RE: Bloomfield Refining Company
#50 County Road 4990
Bloomfield, New Mexico
EPA ID No. NM089416416
Administrative Order on Consent - Docket No. VI-303-H
Response to USEPA Comments on the Draft RFI/CMS Report

**RESPONSE TO USEPA COMMENTS ON THE 11/08/94 DRAFT RFI/CMS REPORT
BLOOMFIELD REFINING COMPANY**

DRAWING:	REVISION:		
<p>FIGURE 1</p>

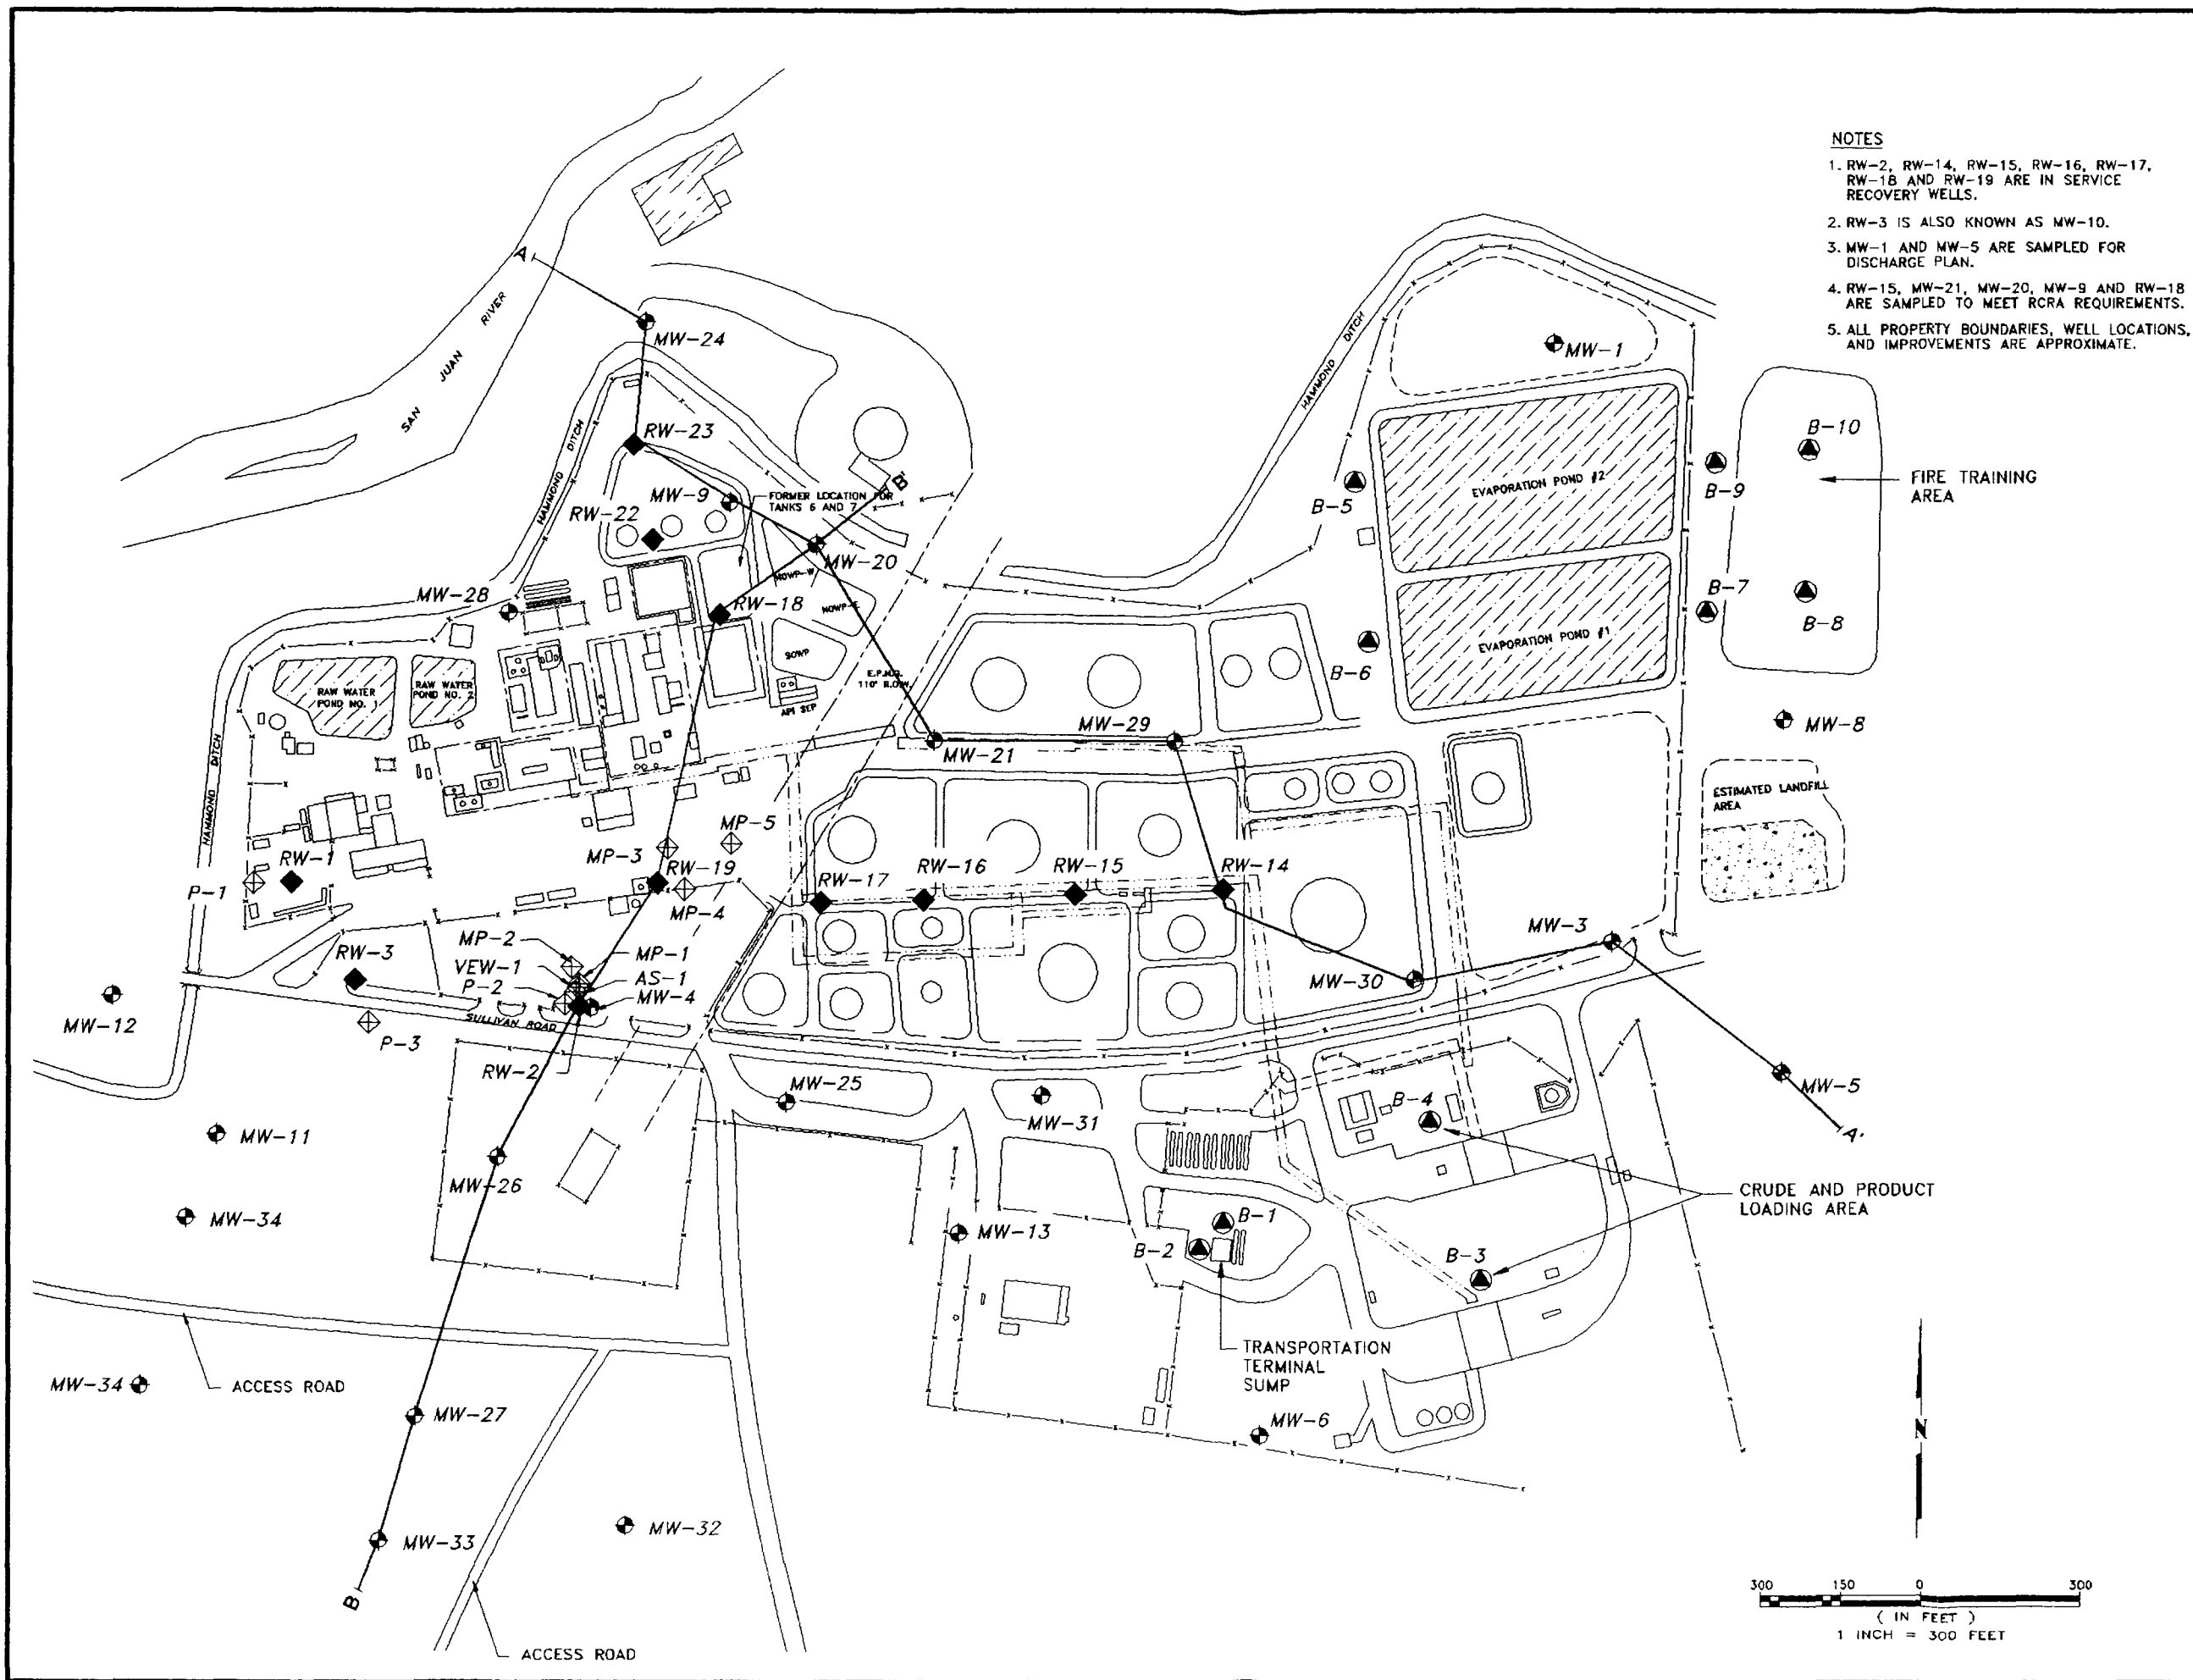
The draft RFI report does not contain any cross sections depicting subsurface geology. As such, the subsurface stratigraphy is difficult to analyze on a site-wide basis. All future submissions must contain the appropriate cross-sections, utilizing available soil borings, recovery wells, and groundwater monitoring wells to adequately characterize subsurface geology.

Response: The locations of the cross sections that have been developed are shown on Figure 1. Cross Section A-A' is shown as Figure 2 and represents a northwest to southeast profile of the site geology and hydrogeology. In general, both the surface topography and the surface of the Nacimiento dip to the west. With the exception of the area around Hammond Ditch, water elevations across the site decrease toward the west and define a relatively shallow, westward trending groundwater gradient. At Hammond Ditch, the saturated zone beneath the ditch is shown as a barrier to the migration of SPH to the north. The primary stratigraphic units in the line of section are clay and silty clay, sand and silty sand, sand with gravels and cobbles, and a gravel/cobble layer. The primary saturated zone across the site is a gravel and cobble layer that is present across much of the site. Cross section B-B' (Figure 3) is a southwest to northwest section through the western area of the facility. Stratigraphic units are similar to those shown on cross section A-A'.

FIGURE 4

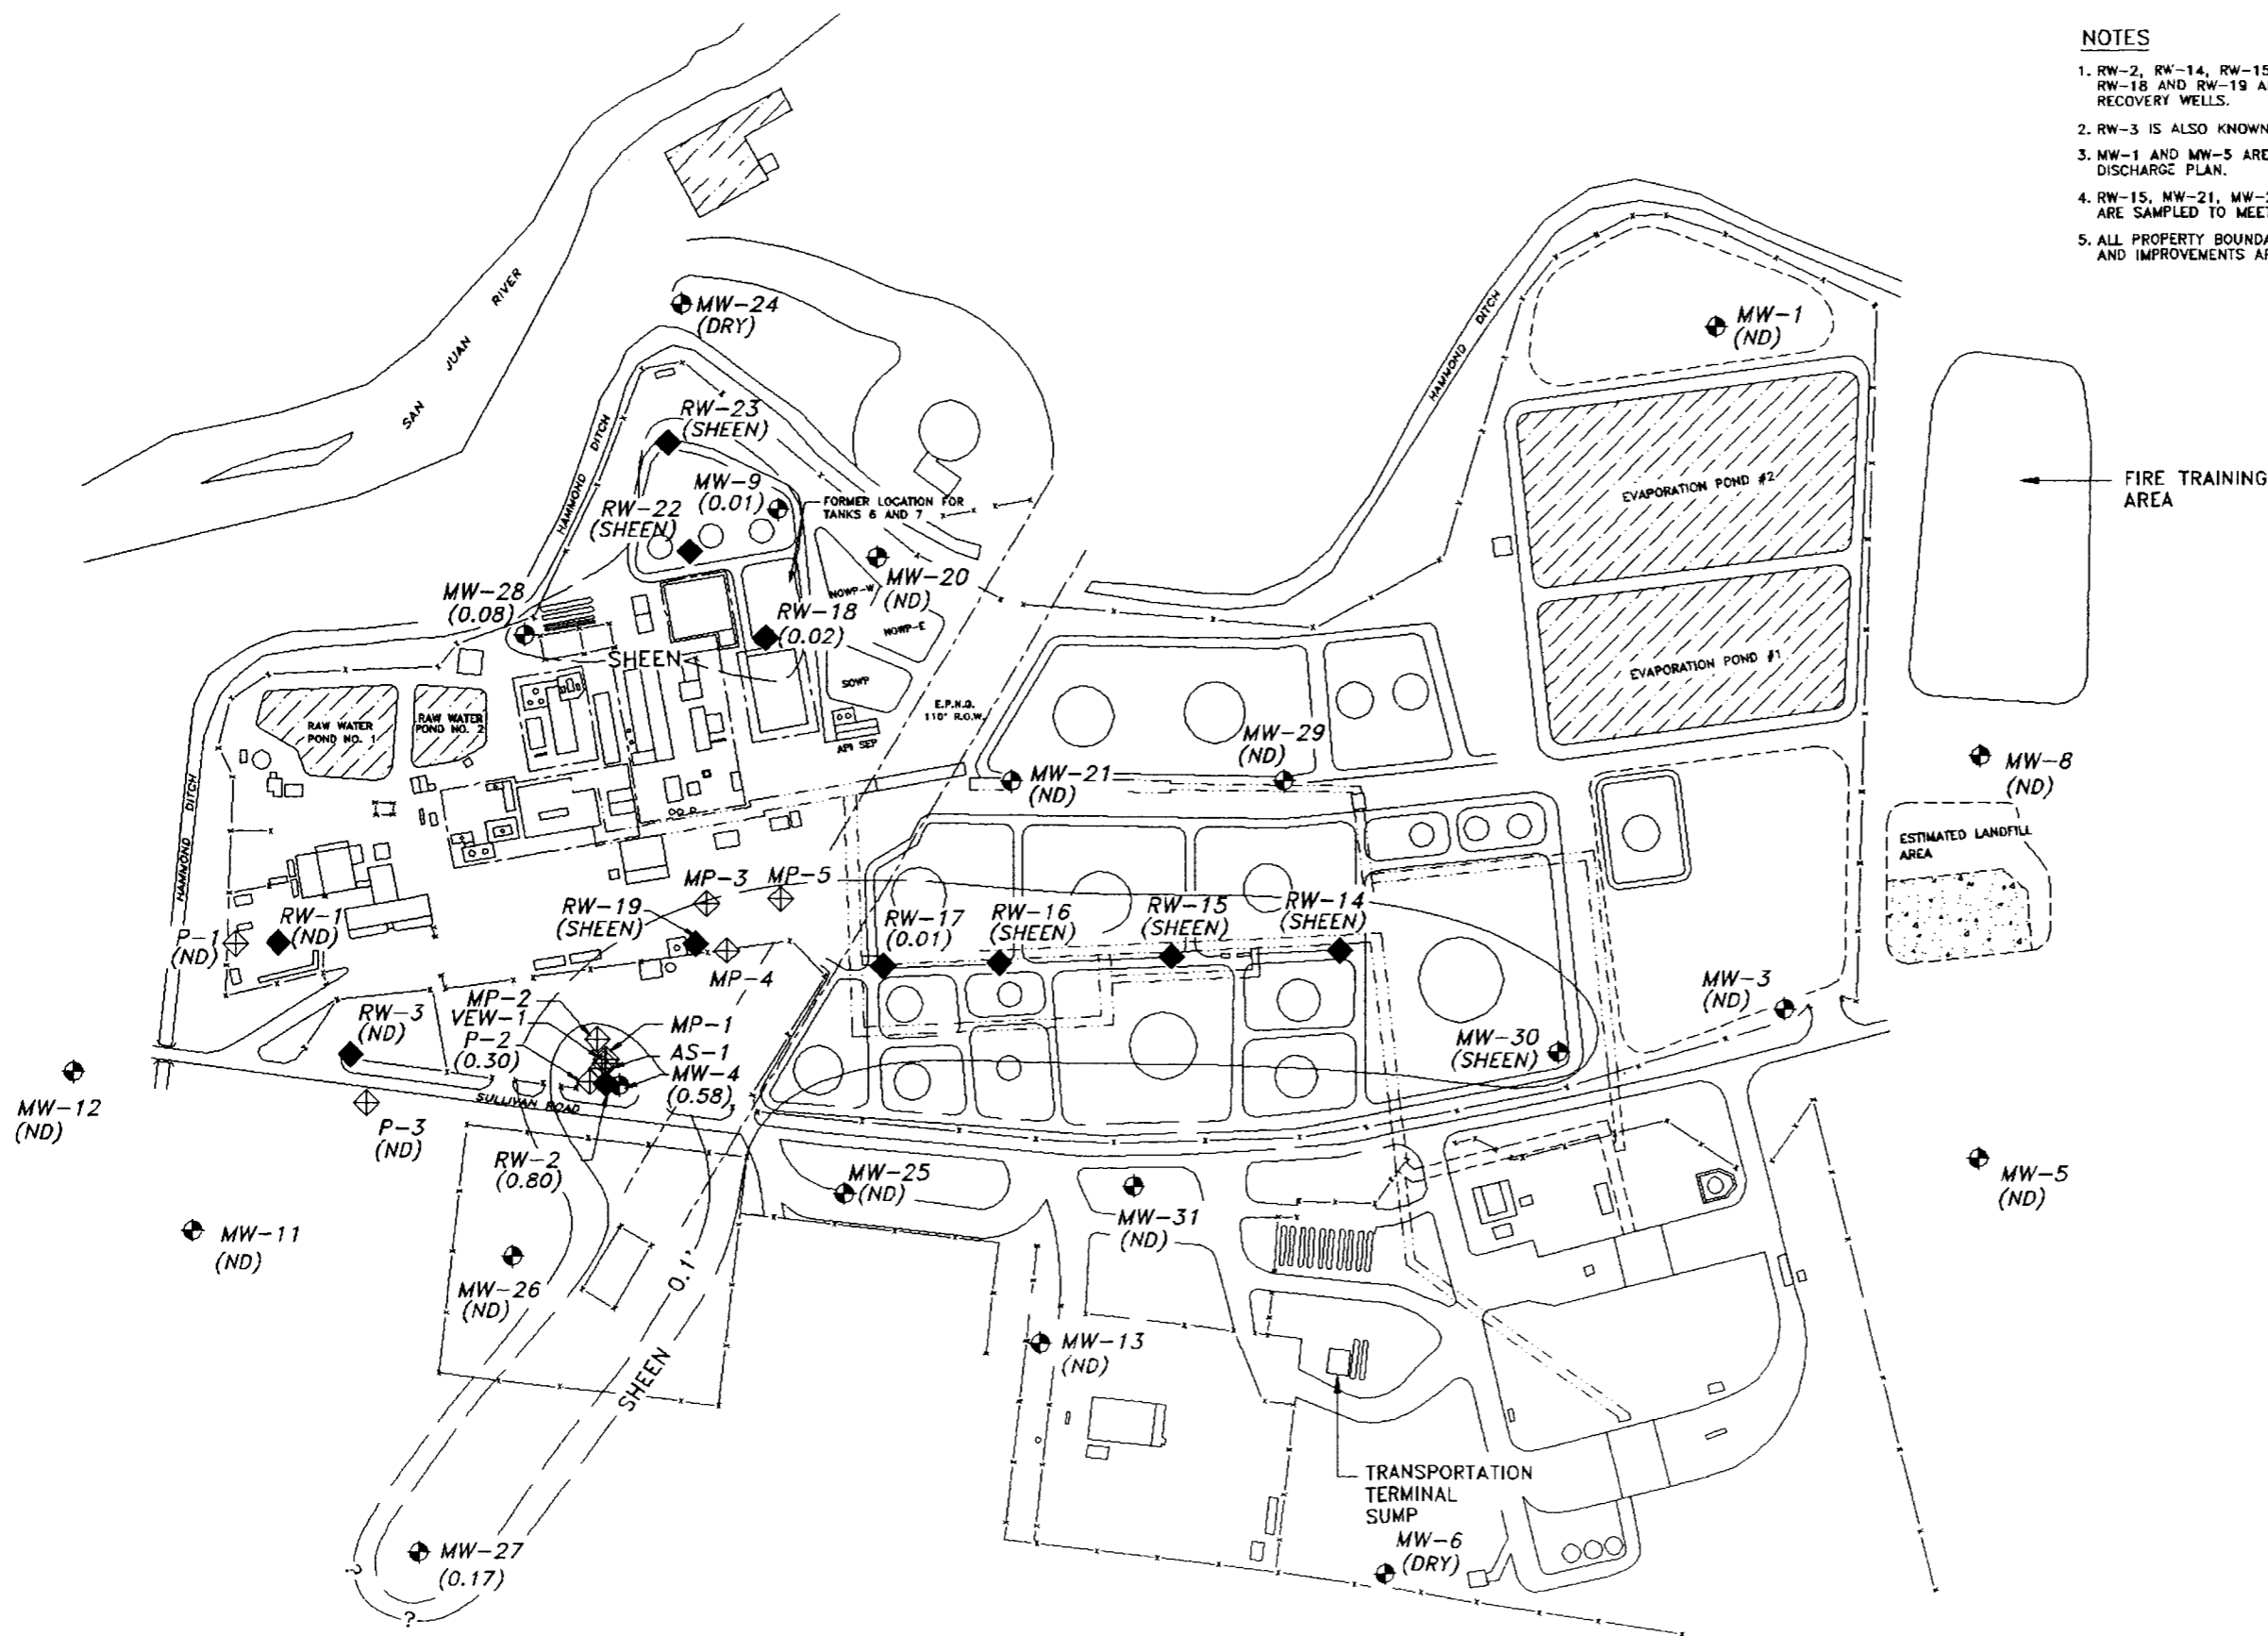
The draft RFI report does not contain any thickness maps showing the limits of groundwater contamination. These maps must be compiled to show the limits of groundwater contamination across the facility as well as off-site.

Figures 4, 5, 6, 7, 8, 9, and 10 depict the extent of SPH, total targeted volatile organics, and total targeted semi-volatile organics, based on the May 24-25, 1994 monitoring data and the August 3-4, 1994 monitoring data. The maps show two main areas of hydrocarbon contamination. Dissolved hydrocarbon and SPH plumes are present along much of the south side of the facility extending southwest along the El Paso Natural Gas pipeline. The levels of SPH in this area are currently controlled by a number of recovery wells. Three additional monitor wells have been installed southwest of the site and plume definition is essentially completed with these wells (the results will be forwarded to USEPA before 1 May 1995). In the northwest corner of the site, another area of hydrocarbon contamination is present. In this area, a thin accumulation of SPH has been identified.
